STATE OF MAINE
DEPARTMENT OF TRANSPORTATION
16 STATE HOUSE STATION
AUGUSTA, MAINE 04333-0016

January 19, 2023
Subject: Acadia Gateway
State WIN: 017163.03
Location: **Trenton**
Amendment No. 5

MAINE DEPARTMENT OF TRANSPORTATION
 ACADIA GATEWAY FACILITY
 INTERMODAL AND WELCOME CENTER

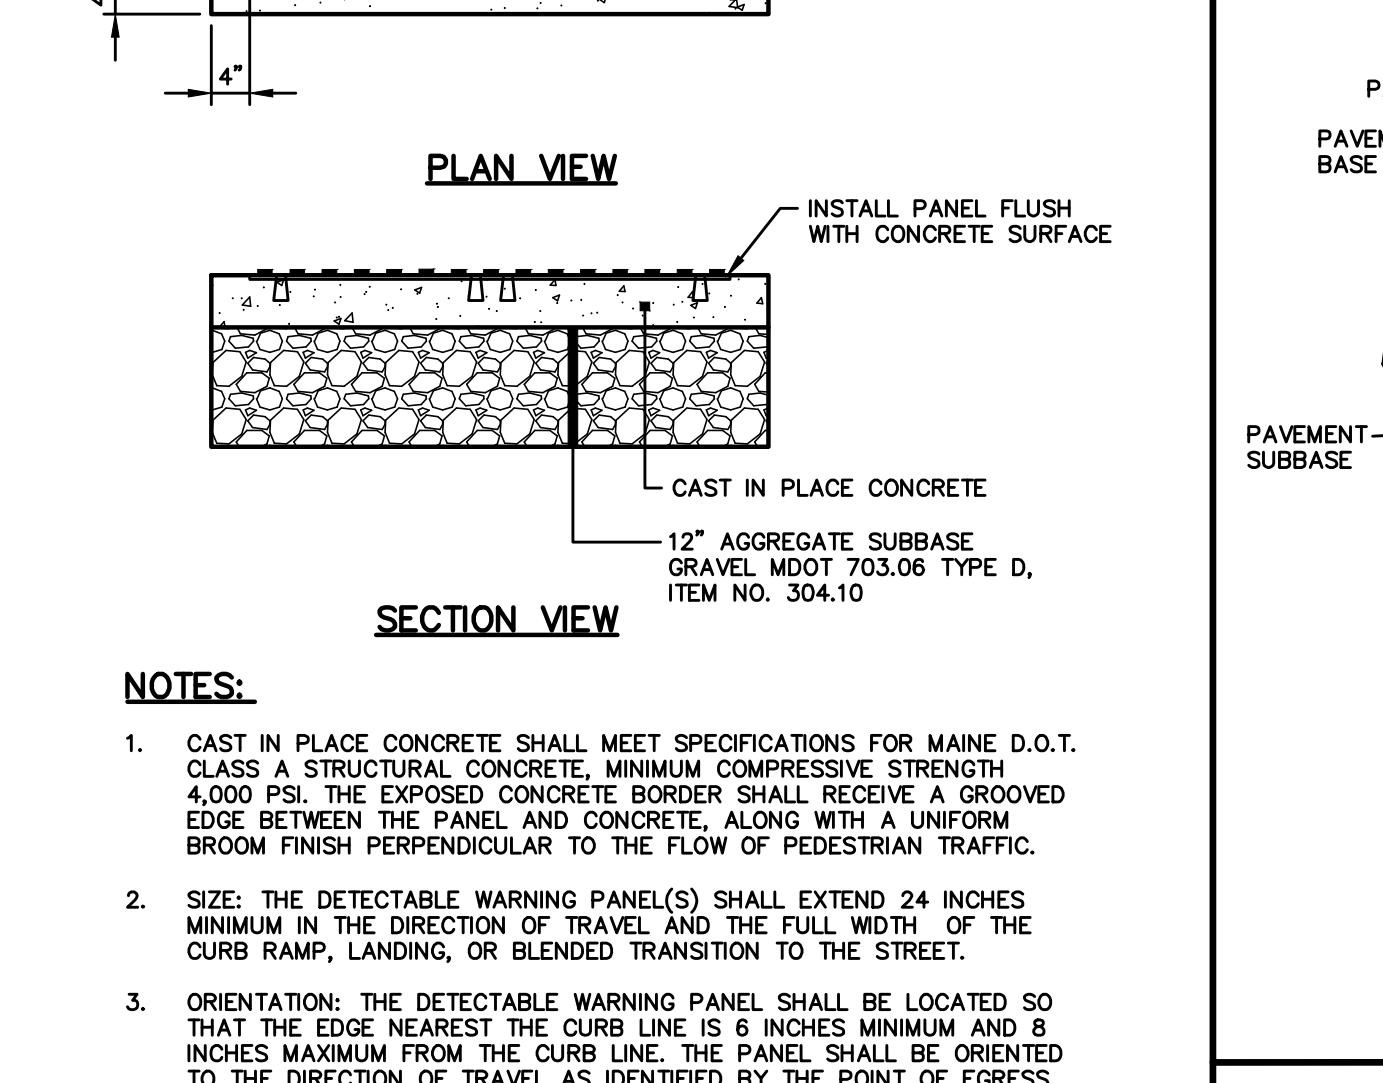
Question: It appears that there is a Ramp with Detectable Warning Pavers near the NE corner of the Bus Shelter, but it is not identified similar to the other Ramps on the plan sheet. Please clarify.

Response: The ramp in this location has been removed. The curb bump out will remain, without a ramp. C202 has been updated in Amendment #5.

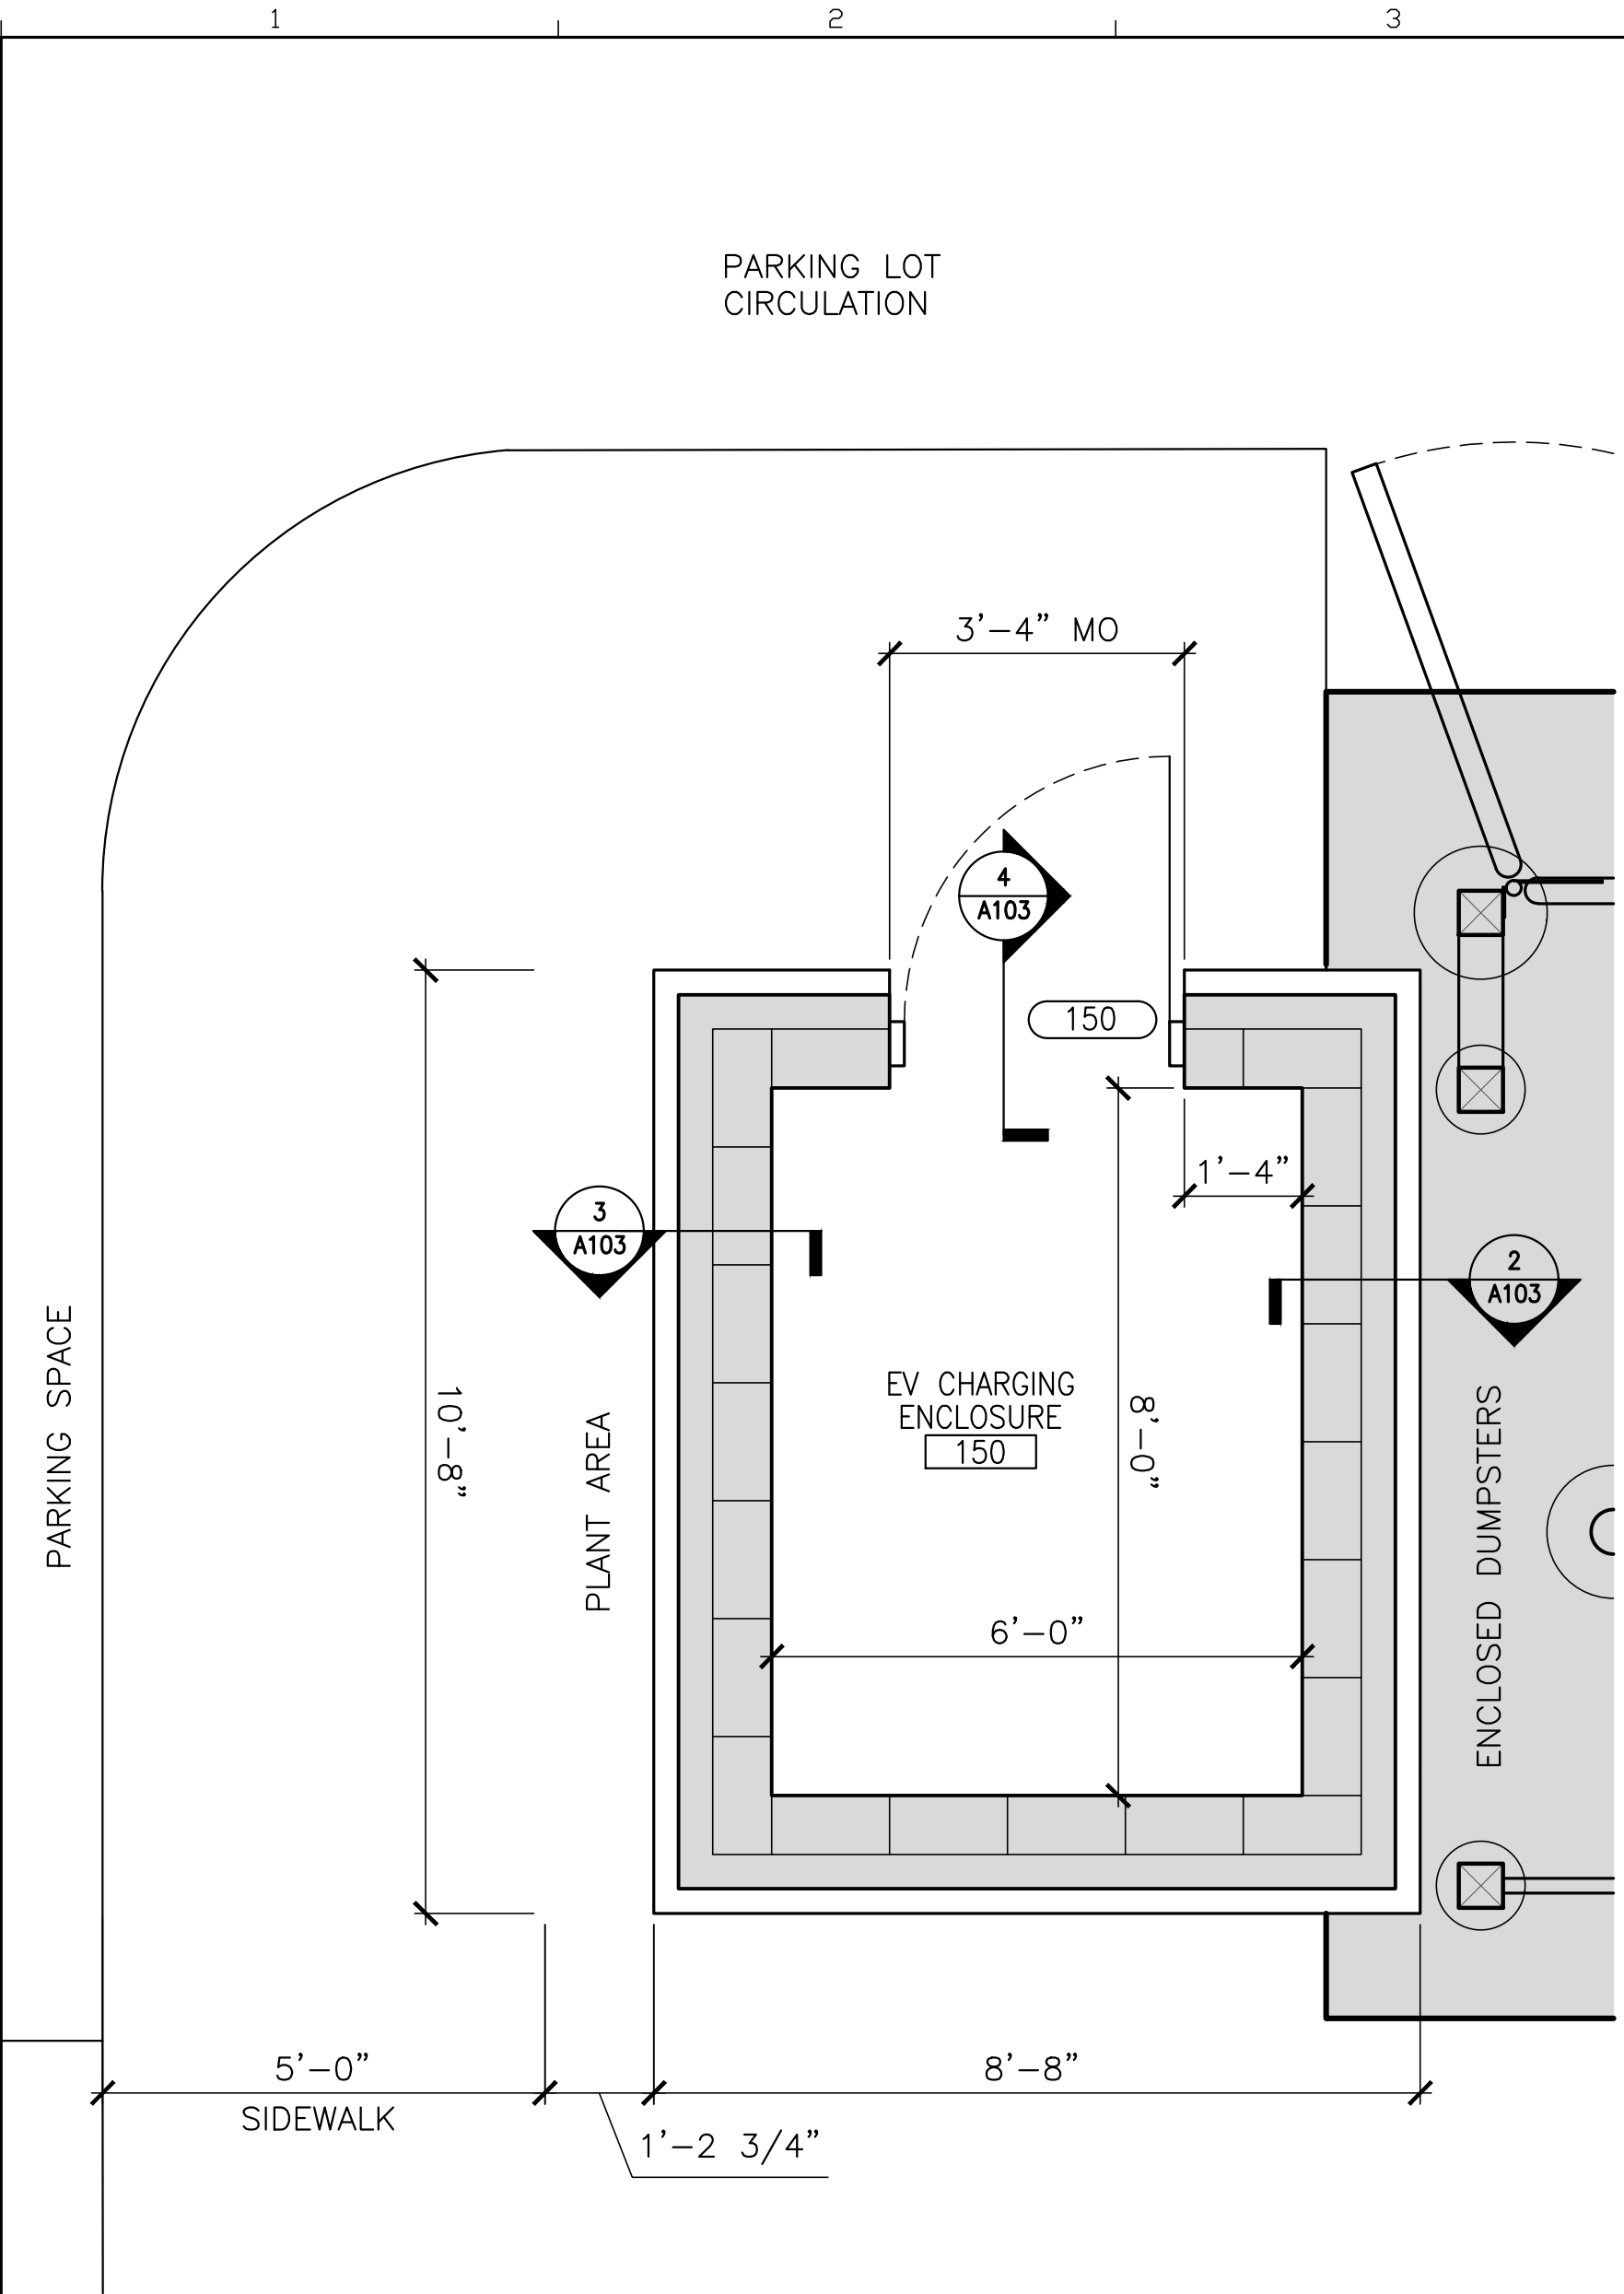
Question: SF602 indicates a 6" SOG for the EV Charging Station. A103 indicates a 4" SOG for the EV Charging Station. Please clarify.

Question: Details 3 & 4 indicate an exterior 4" CIP Concrete slab on the North & West sides of the EV Charging Enclosure. A note on Detail 3/A103 says to refer to the Structural drawings for the exterior 4" CIP Concrete slab. The Structural, Civil, & Landscaping plans do not indicate an exterior 4" CIP Concrete slab on either the North or West sides of the EV Charging Enclosure. Please clarify.

Response: The slab at EV Charging Station is 6" thickness as noted on Sheet SF602. On A103 SOG for the EV Charging Station has been changed to 6" as part of Amendment #4.

Response: On sheet A103, slabs outside the EV enclosure have been changed to match structural, civil, and landscaping plans.

1 FIRST FLOOR PLAN
1/8"=1'-0"

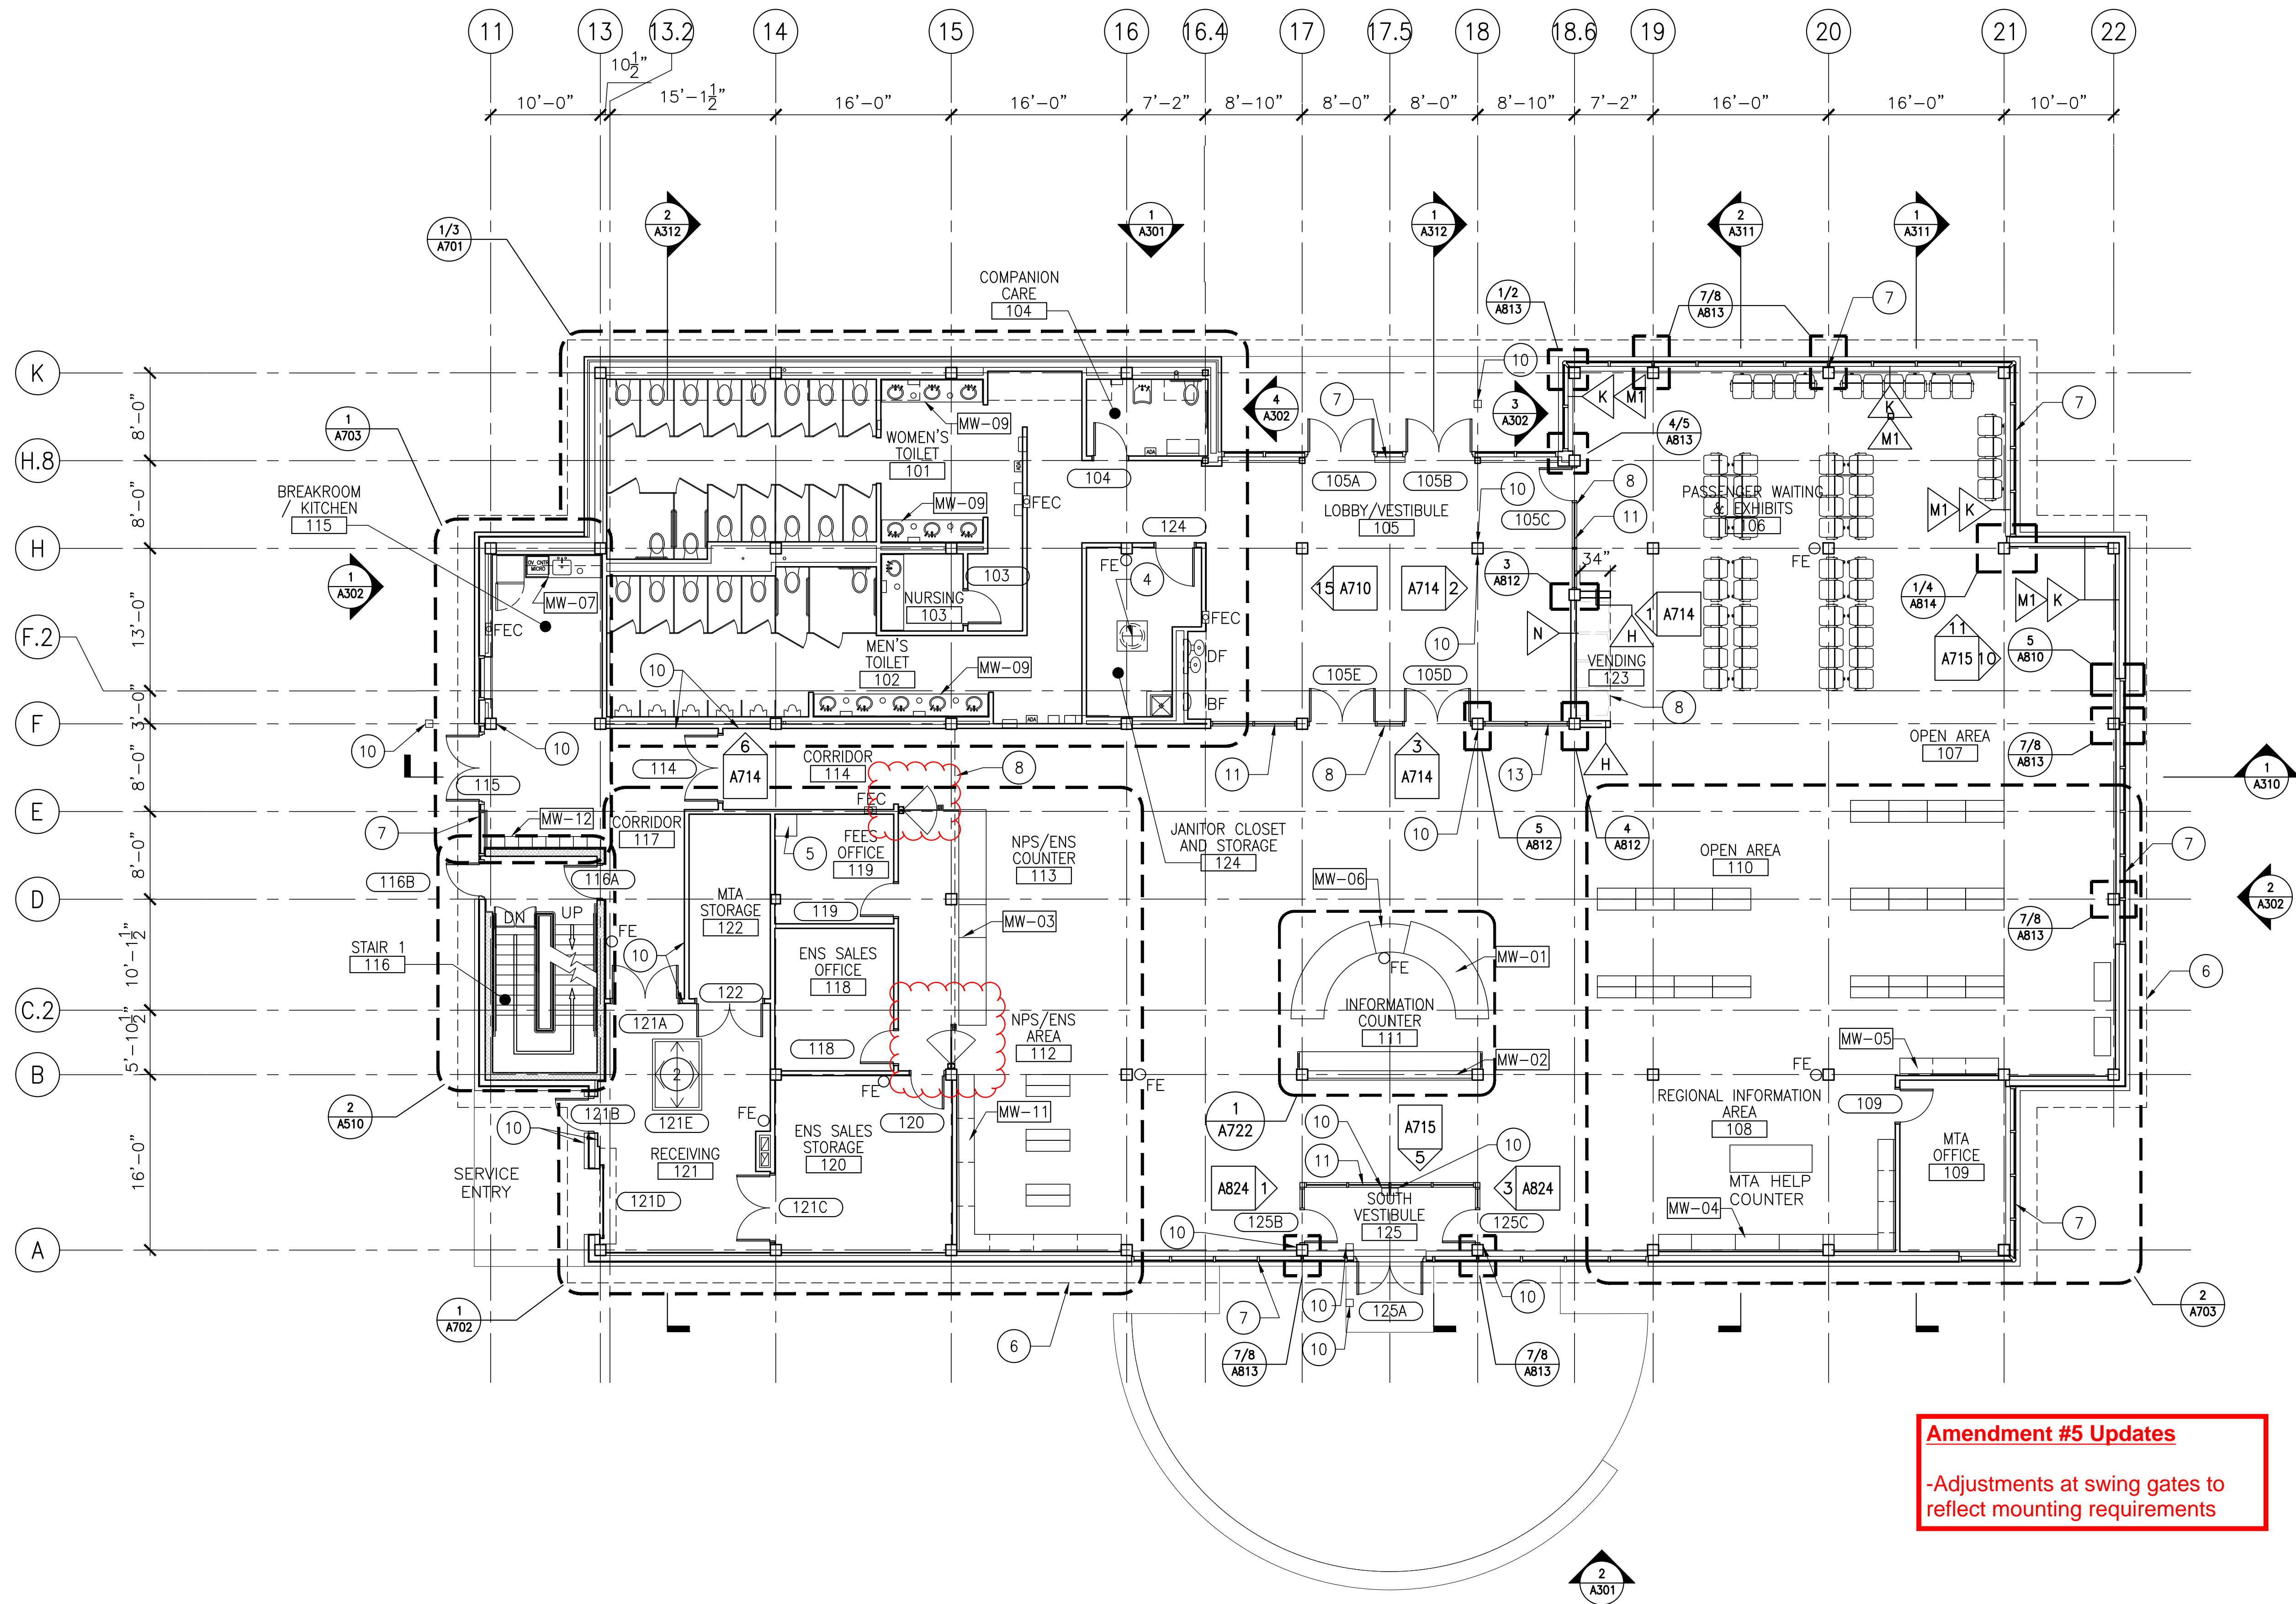
Question: There is a note about 2 counters/gates/panels at MW-03, Rm.#113 listed as TBD. Are details coming?

Response: Details for the two swing gates have been added to the drawings in Amendment #5. Sheets A202, A702, A703, A715, A721, A725 have been updated.
